MEMORANDUM

To:	Anthony Blomfield – Bentley & Co. Ltd	From:	Brett Harries
cc:		HTE File:	cen02
cc:		Date:	28 May 2025
Re:	Jaafar Holdings Ltd – 44 Mt Wellington Highway Variation to Conditions 1 and 10 of Resource Consent LUC60326896 Response to Further Information Request - Traffic

Figure 1: Lane 1 commencement of plan view visual overlap (~40.5m from limit line)

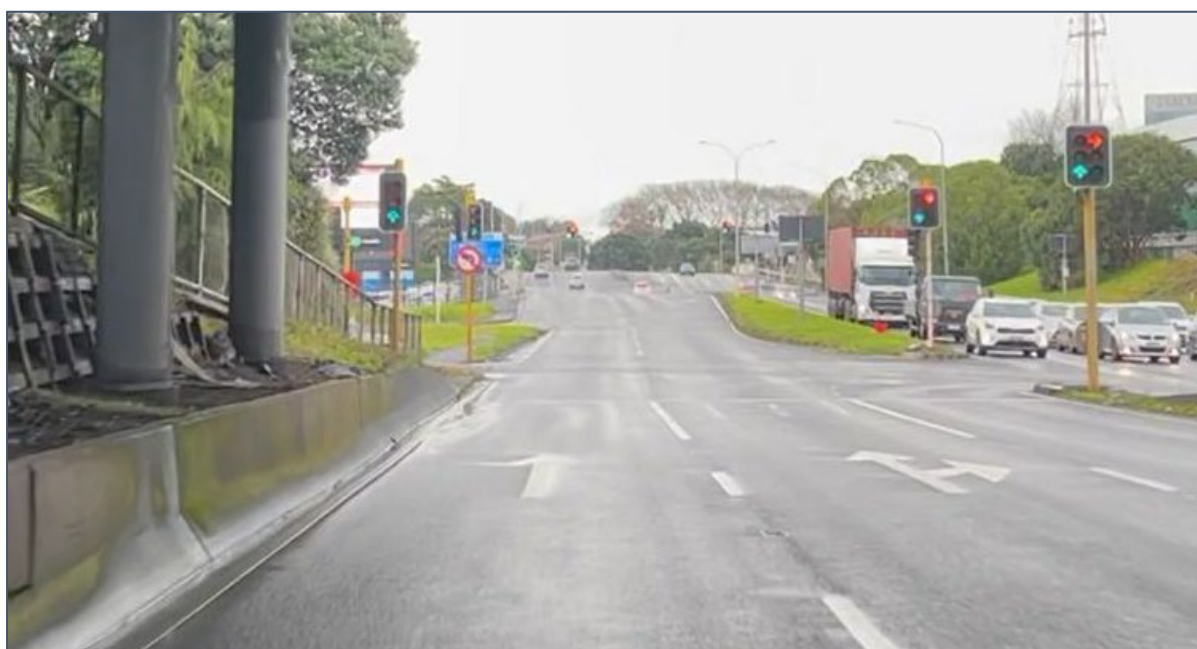
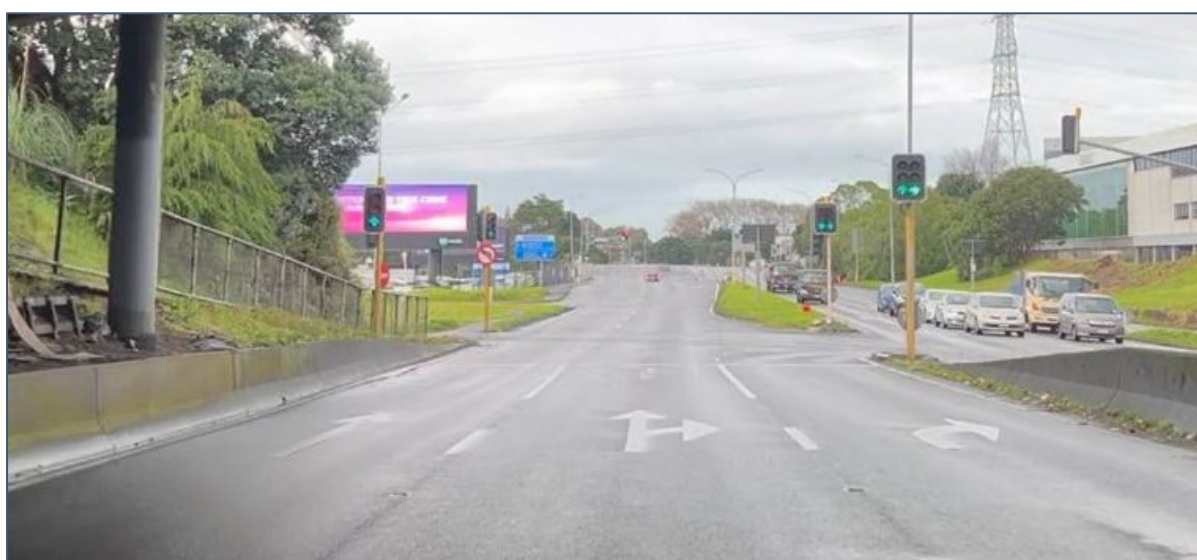
“In Section 3.3.4 of the applicant’s Traffic Engineering Report (TER), the applicant’s traffic specialist refers to the traffic signals in the dual primary and secondary positions for the southbound approach to the intersection of Mount Wellington Highway and the SH1 Motorway northbound on-ramp and southbound off-ramp stating that:

“The prominence of the apparently closely spaced dual primary and secondary signals (each of which has six aspects arranged in two columns) clearly dominates in terms of conspicuity of the full traffic signal set that faces southbound road users.”

The TER does not acknowledge the possibility of trucks restricting visibility of the dual primary or secondary signal displays or assess the potential adverse effects. Please provide an updated traffic assessment, commenting on potential effects of the proposal, taking into account the possibility of trucks blocking the visibility of the dual primary or secondary signal displays, which may force southbound drivers to rely on the signals in the primary and tertiary positions, which have an overlap with the billboard.”

As the variation proposal does not anticipate any physical changes to either the subject billboard or the layout of the intersection, any incidences of a large truck obstructing views of one or both of the dual-primary and/or secondary traffic signal lanterns⁵ for motorists following the truck will not change.

If a large truck was to obstruct both the dual-primary and secondary signals, the query correctly observes that following drivers will be required to rely on the primary and/or the tertiary signals. This is an existing situation that does not change with the proposal.

What is inferred, but not specifically requested in the query, is the possibility that the increased frequency of image change will in some way degrade the ability of motorists to observe or respond to either the primary or tertiary signal if views of the dual-primary and secondary are obstructed. The short answer is that they will not.

When motorists have to, or wish to, rely on the primary and/or tertiary signals to be informed about whether or not they are able to proceed straight through the intersection (the primary and tertiary signals do not inform the right turn onto the northbound on-ramp), even when there is a visual overlap with the billboard, this does not make either of the two traffic signals invisible, nor does it compromise a motorist's ability to recognise their displays despite the contrary perception inferred by the query. This is amply demonstrated in Figures 8 and 13 of the TER, which have been reproduced below, and which show a driver's view of the existing visual overlapping in each of Lane 1 and Lane 2, (Lane 3 views are irrelevant as Lane 3 is a right turn-only lane, and the primary and tertiary signals do not inform the right turn). In each of the Lane 1 and Lane 2 views, the prominence of the primary traffic signal in the foreground is readily apparent. The proposed modification to the dwell time will not diminish that prominence.
